Gary Page
Cluttons LLP

53 WARMINSTER RD - PROGRESS

Tuesday, 1 November 2022

Prepared For Brymore No 1 Ltd

OBSERVATION 9

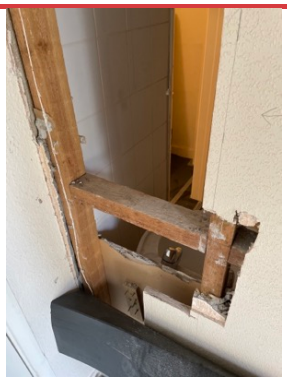
Ceiling within rear lounge room

OBSERVATION 11

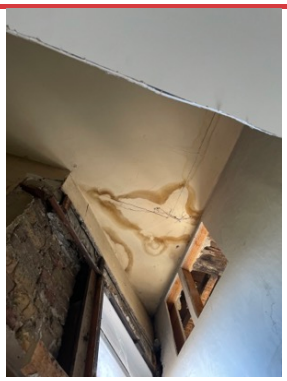
Partition separating Flat F and Flat E

Note timber. Is this an old door opening.

Will this affect loading from revised bay window loading

OBSERVATION 14

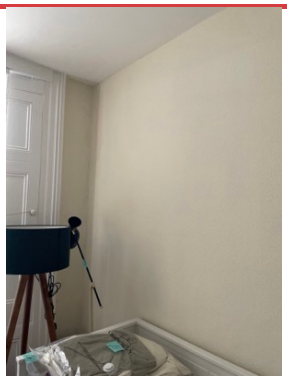
External tank exposed

Spanning of scaffold as contractor had not realised their loading point.

Okay to backfill?

OBSERVATION 15

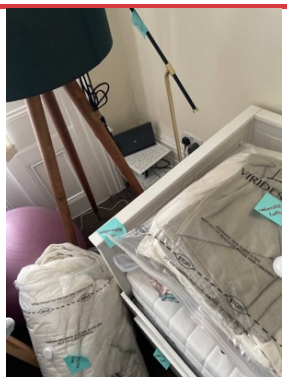
Wall separating Flat F where loading from revised bay window may be required.

OBSERVATION 18

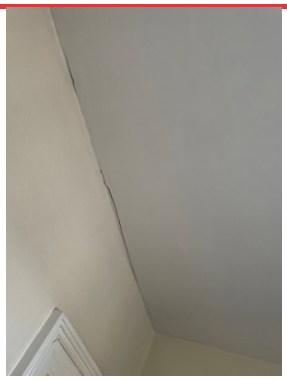
Left flank side hallway

OBSERVATION 21

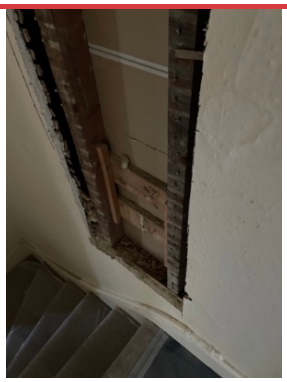
Central hallway stud exposed separating the rear lounge.

Depth from back of lath to wall finish is 120mm.
